Figure 4-1 Average Change in Bed Elevation within the Northern Impoundments for the nine Sensitivity Simulations

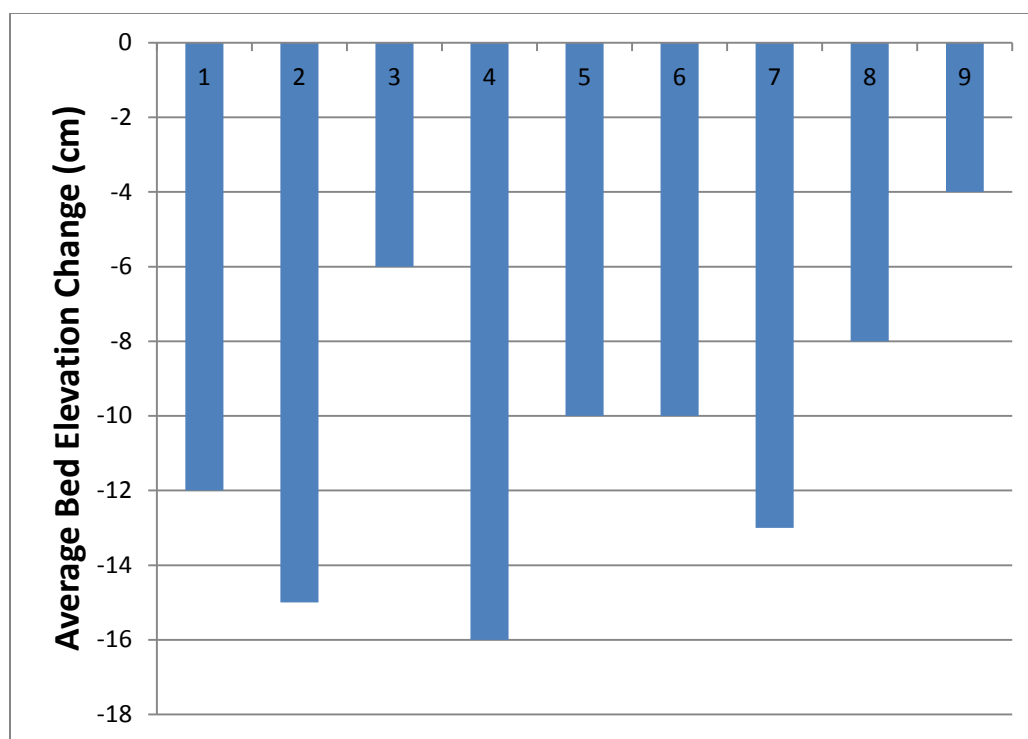
Figure 4-1 shows the results from the three month simulation for the nine sensitivity runs. The numbers (1 through 9) at the top of each bar are the sensitivity run numbers shown in Table 4-1. As expected, all nine simulations showed negative net bed elevation changes (*i.e.*, net erosion) over this three month period. The plotted net bed elevation changes represent the spatially averaged values for the portion of the grid inside the northern impoundments. Net bed elevation change is defined as the difference in bed elevation in a given grid cell from that at the beginning of the simulation to that at the end. As such, the net bed change does not represent the maximum depth of erosion that occurred during the simulated three months. In all cases, the maximum erosion depth was about twice that of the net change. The net change was smaller due to the net deposition that occurred at the site for the period of the model simulation that followed the peak of the 100-year flood.

These nine sensitivity simulations agreed with the conclusions reached by AQ in their model sensitivity analysis. For example, as seen by comparing Runs 3 and 4, decreases in the upstream sediment load causes more net erosion due to less sediment being transported to the SJR estuary, which

in turn results in smaller quantities of sediment being deposited at the Site following the simulated flood. In addition, the following conclusions were developed from the results shown in Figure 4-1.

Figure 7-1 Expanded LTFATE Model Domain used to simulate Hurricane Ike

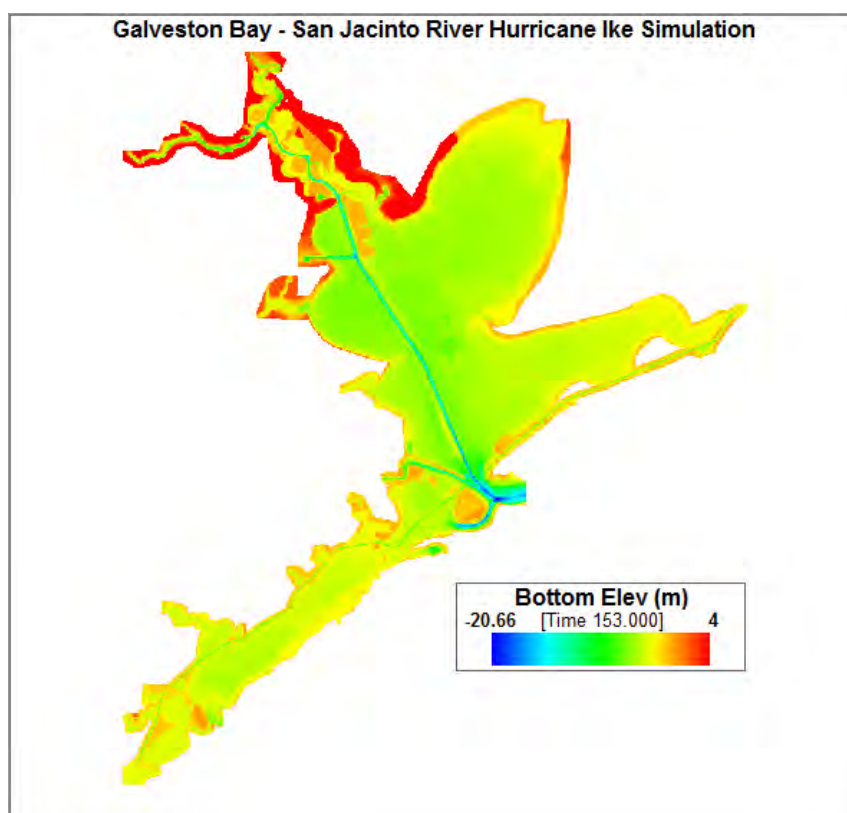
For simulating the impact of Hurricane Ike on the SJR Site, the model domain for LTFATE had to be expanded to include Galveston Bay to be able to simulate the propagation of the storm surge into the SJR estuary. The expanded model domain is shown in Figure 7-1. A Cartesian grid with 131,989 120m by 120m size grid cells was constructed. The time period simulated was June – September 2008. The first 2.5 months of these four months was used to spin-up the hydrodynamic model. A sediment

The results during the peak of the storm surge at the Site showed that the sections of the TCRA Cap (mainly in the Northwestern Area and the southwestern area of the Eastern Cell) using Cap Armor A material ( $D_{50} = 3$  inches) were completely eroded. The two sections using Cap Armor D ( $D_{50} = 10$  inches) were only eroded an average of 15 percent of the 12 and 24 inches thicknesses. The sections using Cap Armor material B/C and C ( $D_{50} = 6$  inches) incurred an average maximum erosion of more than 70 percent. Thus, approximately 60 percent (11 acres) of the 15.7 acre impoundment incurred severe erosion.

The most severe event simulated as a component of this task was the hypothetical synoptic occurrence of Hurricane Ike and the October 1994 flood, with a peak discharge of approximately 11,000 cms (390,000 cfs) occurring at the time of the peak storm surge height at the Site. The maximum scour depth in any grid cell within the cap boundary during this hypothetical extreme event was 2.4 ft (0.73 m). The results during the peak of the storm surge at the Site showed that the sections using Cap Armor A ( $D_{50} = 3$  inches) were completely eroded, while the sections using Cap Armor D ( $D_{50} = 10$  inches) were only eroded more than 12 inches in about 25 percent of those sections. The sections using Cap Armor B/C and C ( $D_{50} = 6$  inches) incurred a maximum erosion of more than 9 inches in about 85 percent of those areas. Thus, approximately 80 percent (12.5 acres) of the 15.7 acre impoundment was simulated to incur severe erosion, and an estimated 170 g of 2,3,7,8-TCDF (which was the only dioxin/furan congener modeled) would be resuspended. Replacement of all the Cap Armor materials with a median size of at least  $D_{50} = 12$  inches would be needed to greatly reduce the amount of scour that occurs during such an extreme event.

Figure 9. Dioxin and Furan Fingerprints for 2015 Sediment Samples Collected from Within the Delineated Area.

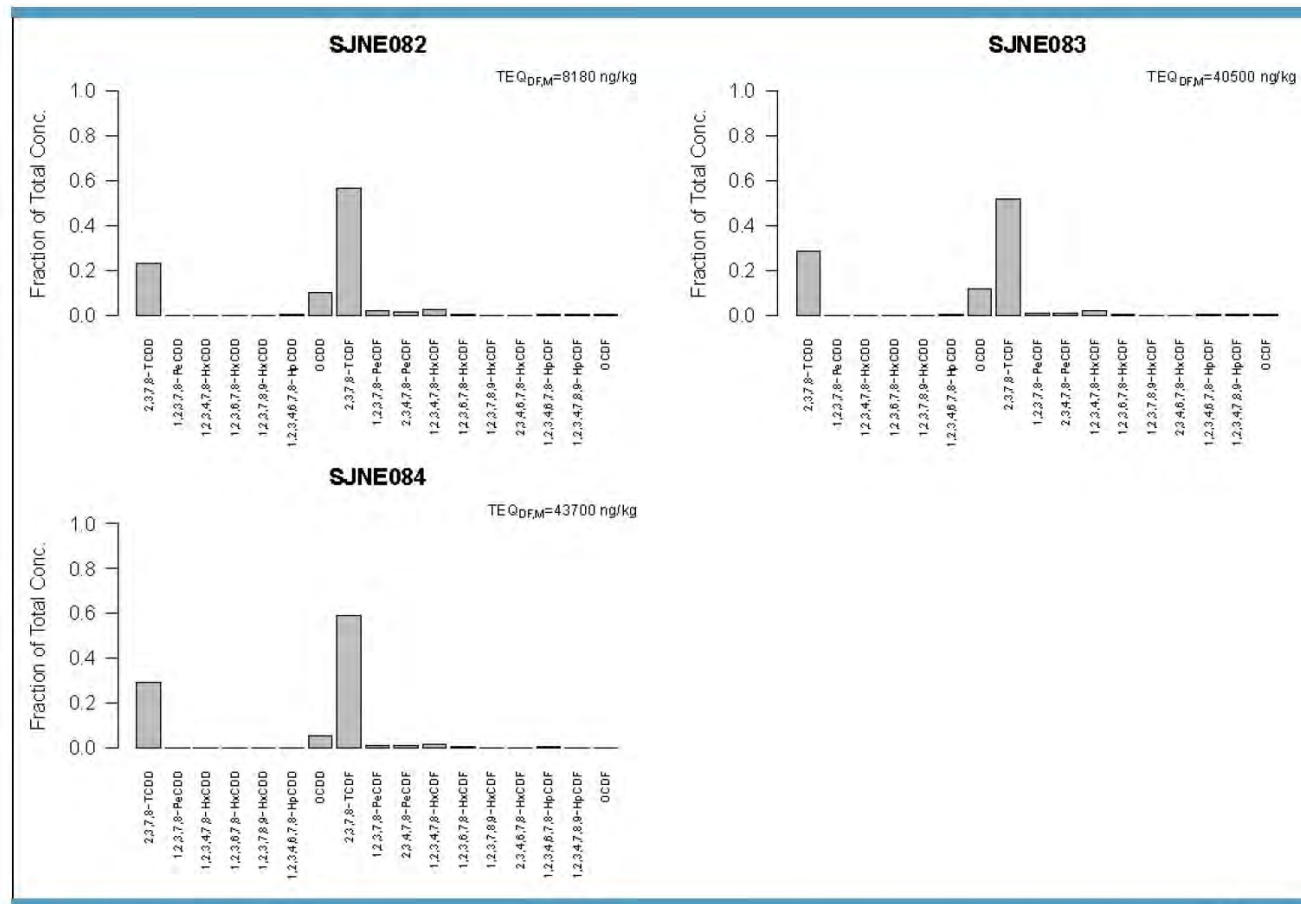
The levels of the two samples (SJNE085 and SJNE 086) from the northwest toe of the cap's sloped area near the cap deficiency area are shown in Figure 9. The levels are 500 times lower than the two highest values at the impacted zone and 100 times lower than the lowest value from the impacted zone.

In addition, the samples outside the armor cap area do not contain significant TCDD and TCDF levels as compared to those from the exposed sediment in the armor cap area (see Figure 9). This difference in the distribution of dioxins and furans between the two samples indicates that the contamination outside the armor cap area did not come from the exposed sediment in the armor cap area, providing another piece of evidence that the exposed sediment from the armor cap area did not contributed significant releases to the surrounding sediment.

Comparison of Figure 12 with Figures 9 and 10 shows that the fingerprint from the sediments collected in the deficient area is close to the EM2 model, while the data from the sites outside the exposed area follow the EM1 model. If sediment from the deficient area was released the impacted sites would exhibit a form of the EM2 model (fingerprint), one can say that there is a slight contribution by the short peak of TCDF, so most of the sediment from the toe and outside areas receive most of the loadings from other areas beside the SJRWP. In addition, the samples from the deficient area show evidence of deposition of sediment from outside the SJRWP due to presence of higher distribution of OCDD than in the EM2 model. The presence of deposition in the deficient area would indicate the long-term presence of the defect, the stability of sediment at the defect, and no significant release of contaminants from the deficient area.

Figure 10. Dioxin and Furan Fingerprints for 2015 Sediment Samples Collected from Outside the Delineated Area.

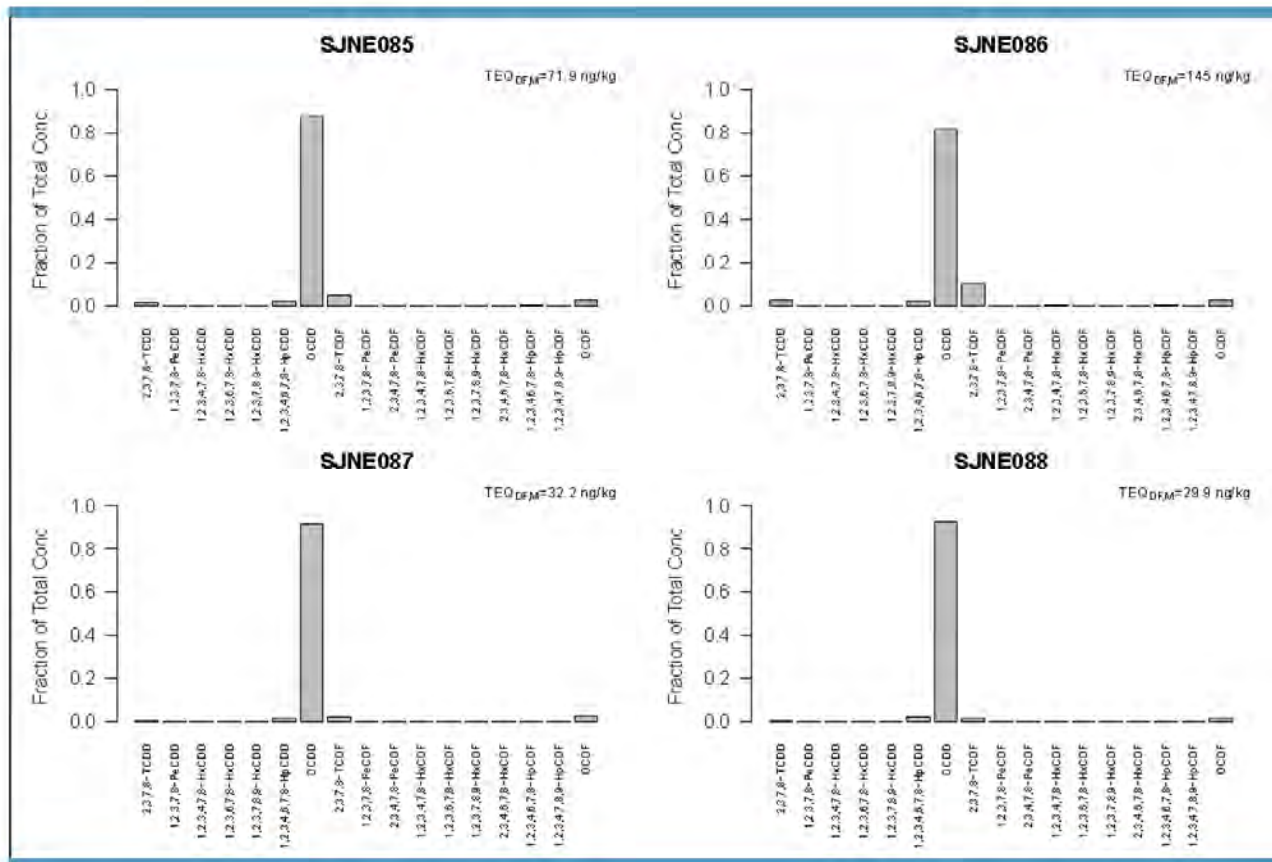
The third set of sediment samples collected were two samples (SJNE87 and SJNE88) approximately 50 feet from the northwest toe of the cap also shown in Figure 8 and the results are also included in Figure 10. The levels are three orders of magnitude lower than the two highest values at the impacted zone and 300 times lower than the lowest value from the impacted zone. The values are three times lower than those samples collected near the northwest toe.

**Figure A7. Work area boundaries and sample collection.**

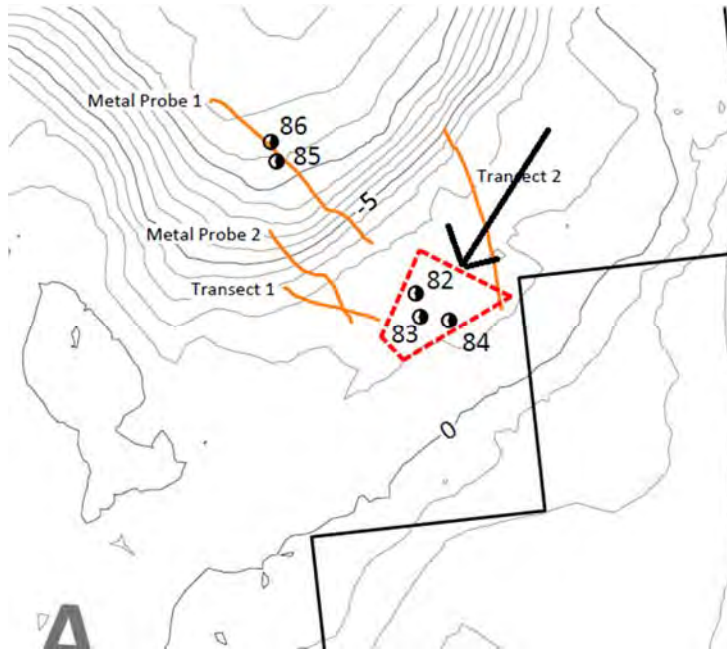
Looking at the area of impact/deficiency as delineated in Figure A7 shows that angle of impact from a barge/tug strike should have occurred from the northwest (where sample 82 was collected, toward sample 83, see Figure A8). That follows the wedge that a tug would have created. The difficulty with that strike is that there is a ridge on that side of the deficient area as shown in Figures A2-A6, and that

ridge/rocks on that area do not show any impact or disturbance (see Figures A5 and A6).
